ARH Knit Composite Ltd. (11386)

ACCORD
on Fire and Building Safety in Bangladesh

Identified Priority 1 Concerns

Photo taken at the 4th floor level
(roof)

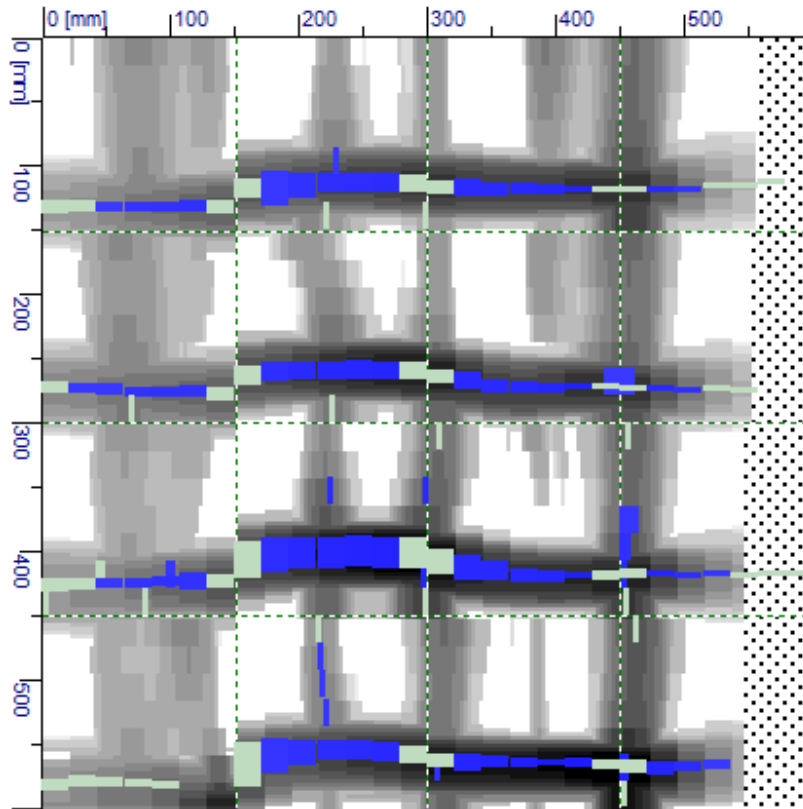
**Intent to continue construction beyond the
5th Storey**

The owner intends to continue construction up to the 10th storey.
Column load run-downs indicate very high column stresses for a 10 Storey Construction:

- **To build to 7th storey + roof:** A Structural Engineer must assess the structure in conjunction with the lack of reinforcing steel in the columns and the column stresses developed over the height of 7 storeys (plus basement).
- **To build to 9th storey + roof:** A Detailed Engineering Assessment is required to validate the suitability of the materials and construction to support the additional levels.

For both cases; implement any corrective works prescribed by the Detailed Engineering Assessment.
